**LAND TO THE EAST/ADJACENT TO 279
QUEMERFORD**

DRAINAGE STRATEGY

Document Reference: Drainage Strategy

Application No: PL/2025/04563
Approval of details reserved by a condition
Discharge of conditions 4 (cycle parking), 8 (surface water) and 9 (cycle parking) of
PL/2024/09508
Land to the east/adjacent to 279 Quemerford, Calne, Wiltshire, SN11 8LA

- Drawing No.2338.08.02.Rev.D Proposed Site Plan

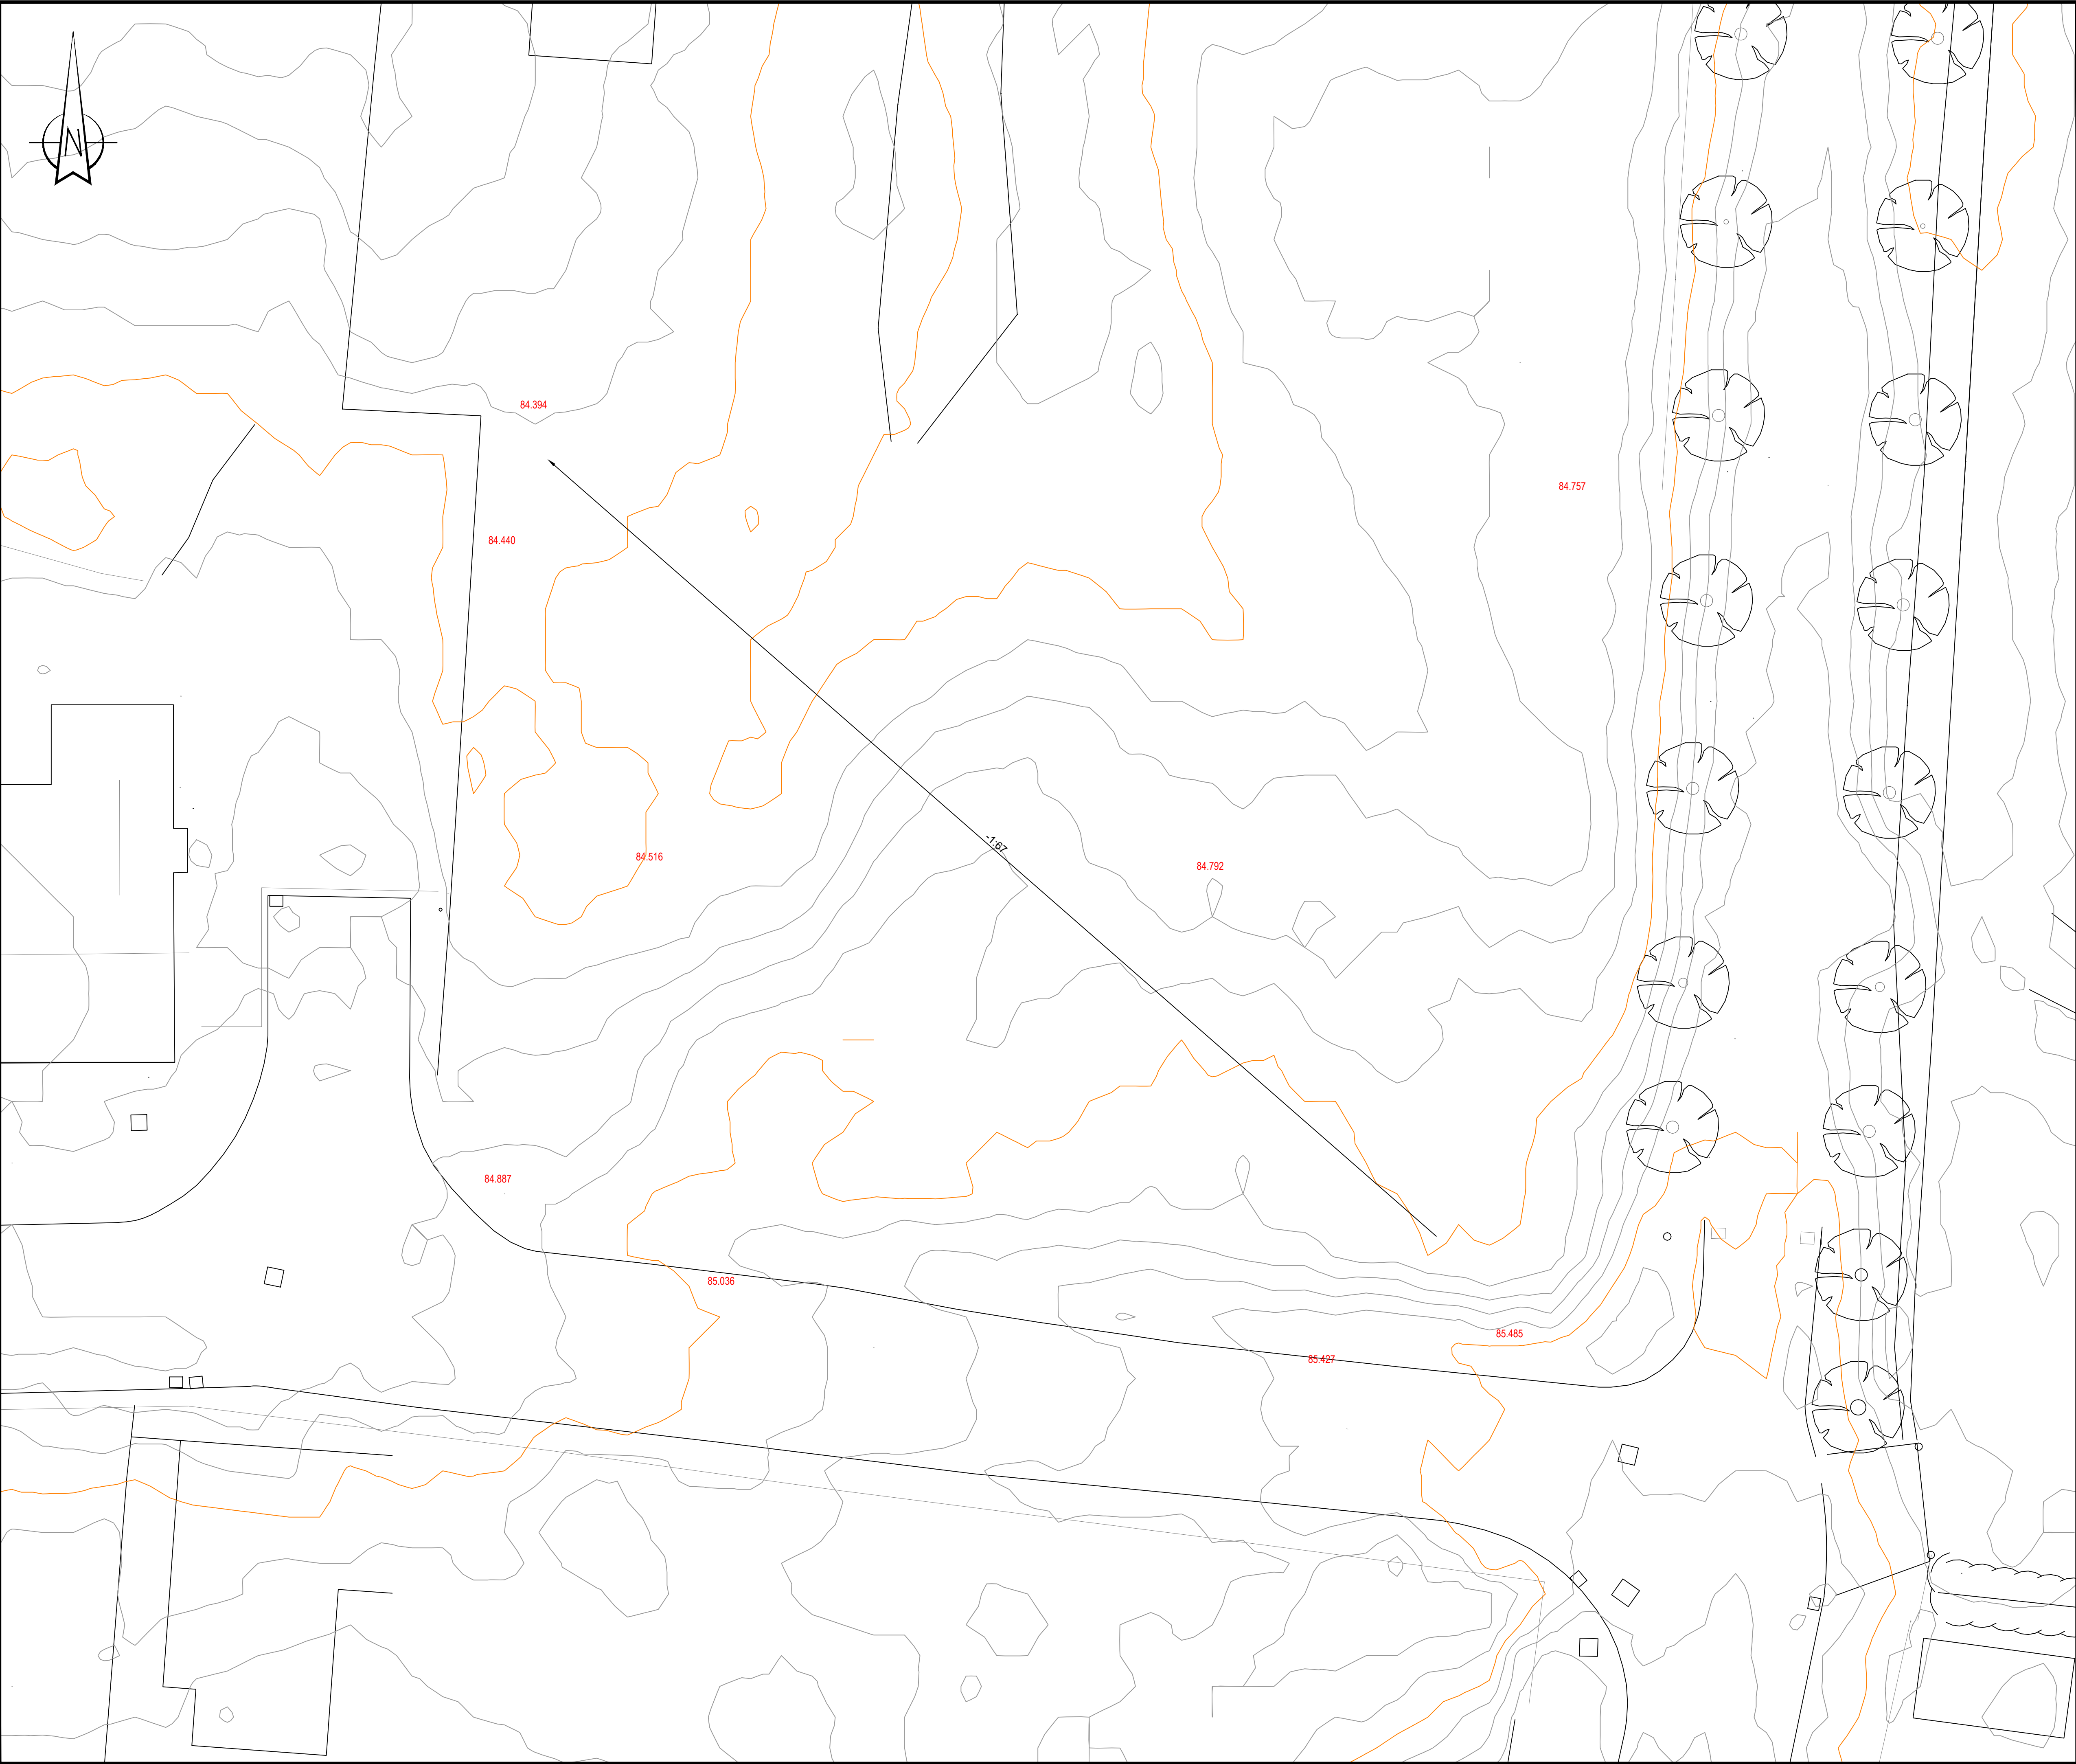
Condition 8 cannot be discharged until the information highlighted in blue is submitted and accepted by the LLFA. Furthermore, it is noted that the drawing states: "Existing surface water drainage for existing dwellings that connect to surface water drainage ditch."

The applicant is also to confirm if the drainage ditch has capacity and that consent has been obtained for the SW discharge.
